Amendments to the Drawings:

The attached sheets of drawings include changes to Figures 5-7, 9, 10, and 12-14.

Annotated Sheets Showing Changes

FIG. 6

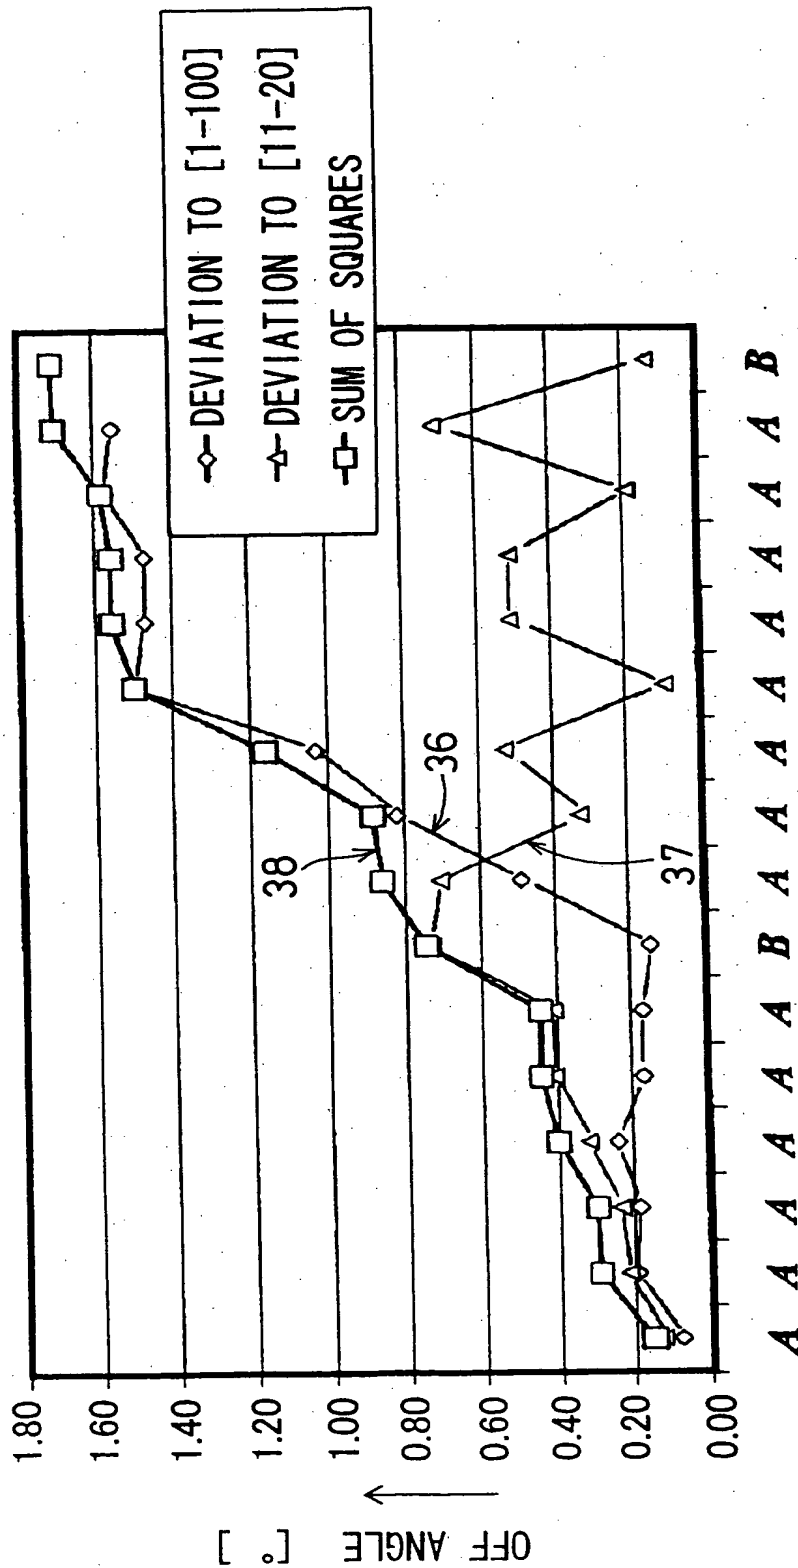
SURFACE ~~STATE~~ A ($250\mu\text{m} \times 190\mu\text{m}$)
MORPHOLOGY

FIG. 9

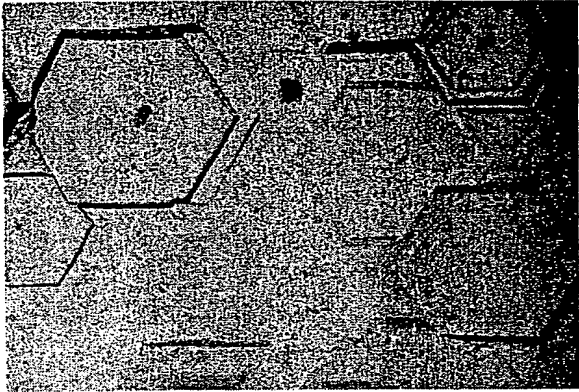
1100°C OR MORE 0.25 873 ~~SECONDS~~
ARCSECONDS 400°C 0.8 —

725°C 0.6 760 ~~SECONDS~~
ARCSECONDS

850°C 0.5 596 ~~SECONDS~~
ARCSECONDS

FIG. 12

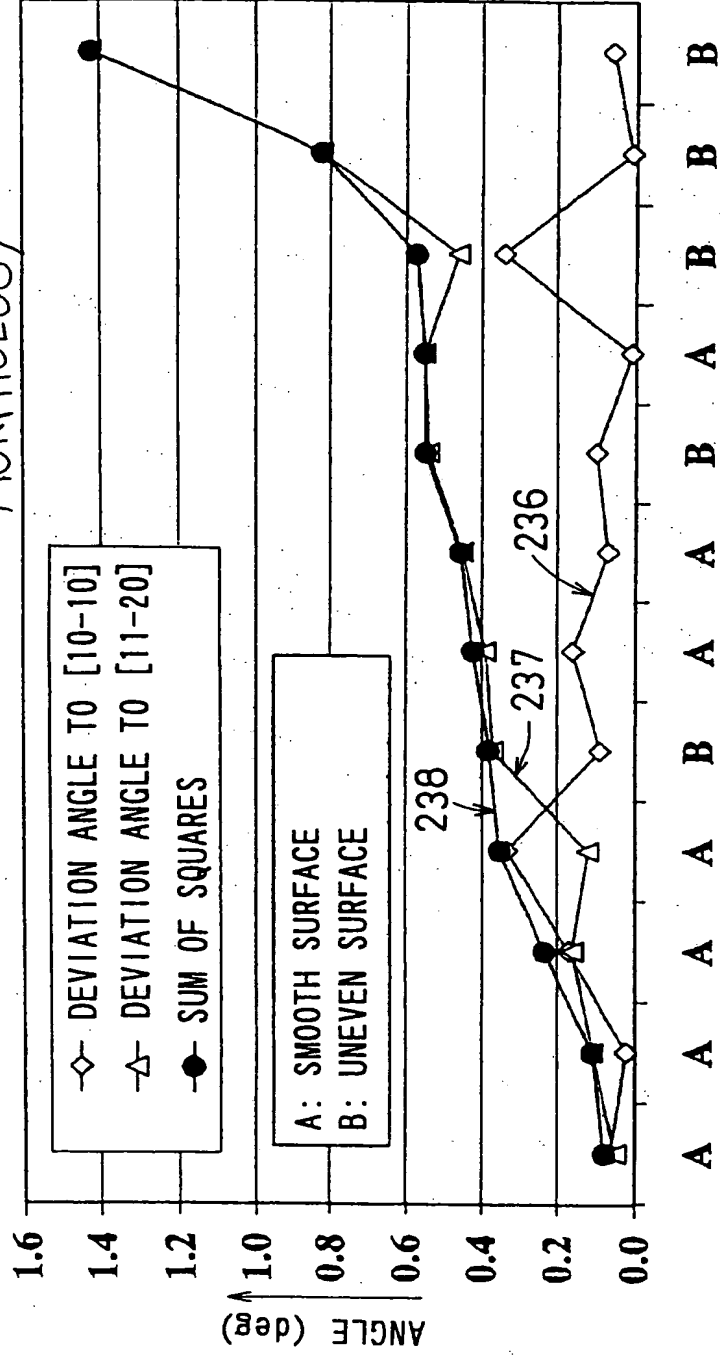
RELATION BETWEEN OFF ANGLE OF NORMAL LINE OF SURFACE OF ZrB_2 BOARD-
 FROM [0001] CRYSTAL AXIS AND SURFACE STATE OF GaN EPITAXY FILM
 MORPHOLOGY

SURFACE STATE OF GaN EPITAXY FILM
 MORPHOLOGY
